Access Compliance Report

Public Rights-of-Way

Intersection ID: 7277	Main Street: NORTHRIDGE_VILLAGE_DR	Cross Street: TOM_HUNTER_RD	Location: NW
ADA ID: 2C090927D265	Ramp Type: Para	Initial Pass/Fail: Fail	Overall Compliance: No
Severity Score: 12.5			
Codes/Mitigation Info/Possible Solution		Field Measurements/Component Compliance

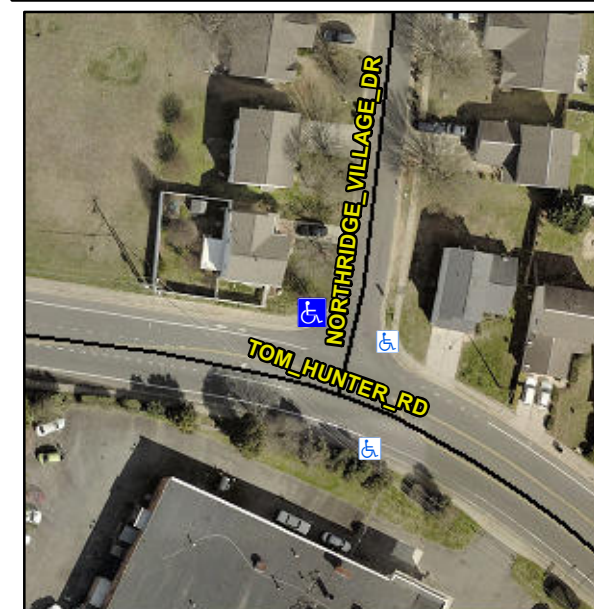
NO RT SW, LT RP < 5%; CURB GAP 1.5

R304.5.3

Compliance	Description	Data	Compliance	Description	Data
N/A	Ramp Length LT (in)	48.0	N/A	Ramp Length RT (in)	53.0
Yes	Ramp Width LT (in)	60.0	Yes	Ramp Width RT (in)	60.0
Yes	Ramp Slope LT (%)	4.2	Yes	Ramp Slope RT (%)	6.2
No	Ramp XSlope LT (%)	5.8	No	Ramp XSlope RT (%)	5.5
N/A	Landing Length (in)	N/A	N/A	DWS Provided?	N/A
N/A	Landing Width (in)	N/A	N/A	DWS Contrast?	N/A
N/A	Landing Slope (%)	N/A	N/A	DWS Length (in)	N/A
N/A	Landing X Slope (%)	N/A	N/A	DWS Full Width?	N/A
N/A	Landing Curb? (Y/N)	N/A	N/A	DWS Offset (in)	N/A
N/A	Shared Landing?	N/A			
N/A	Gutter Ponding?	N/A	N/A	Gutter Slope (%)	N/A
N/A	Gutter Lip Ht (in)	N/A	N/A	Gutter X Slope (%)	N/A
N/A	Painted X Walk1?	No	N/A	Painted X Walk2?	No
	X Walk 1 Direction	To S		X Walk 2 Direction	To E
N/A	X Walk 1 Width (in)	N/A	N/A	X Walk 2 Width (in)	N/A
	X Walk 1 Slope (%)	0.3		X Walk 2 Slope (%)	3.2
	X Walk 1 X Slope (%)	3.1		X Walk 2 X Slope (%)	1.4
N/A	Ramp inside XWalk1?	N/A	N/A	Ramp inside XWalk2?	N/A

Remove & Replace Entire Ramp.
